12 October 2021

NSW Department of Planning, Industry and Environment
Regional Assessments
4 Parramatta Square, Darcey Street
Parramatta NSW 2150

RE: RESPONSE TO REQUEST FOR ADDITIONAL INFORMATION FOR SSD-10224, NEW PRIMARY SCHOOL AT EDMONDSON PARK

Figure 2: Extract of amendment to western elevation (Faulkner Way) (Source: TKD)

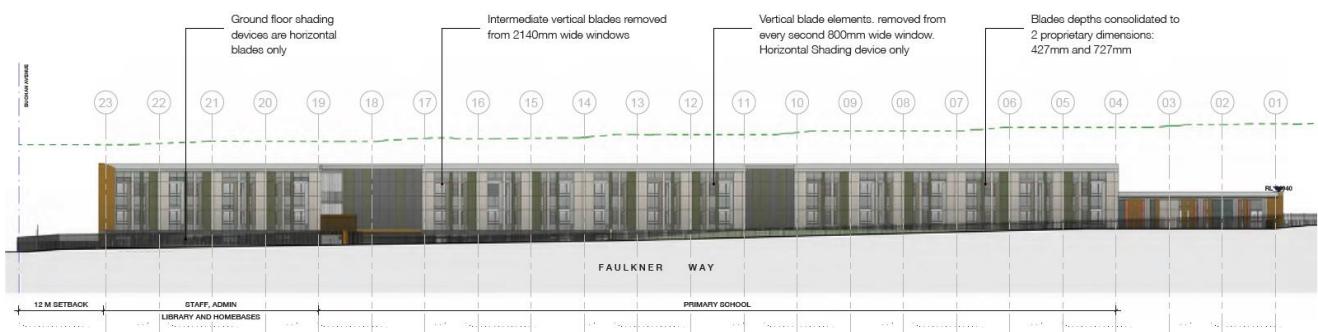
As shown on the Amended Architectural Plans in Appendix 2, SINSW seeks consent to amend the design of the sun-shades on the western elevation of the Faulkner Way building. The changes involve:

- Ground floor shading devices with horizontal blades only;
- Intermediate vertical blades removed from 2,140mm wide windows;
- Vertical blade elements removed from every second 800mm wide window, providing horizontal shading device only; and
- Blade depths consolidated to two proprietary dimensions – 427mm and 727mm.
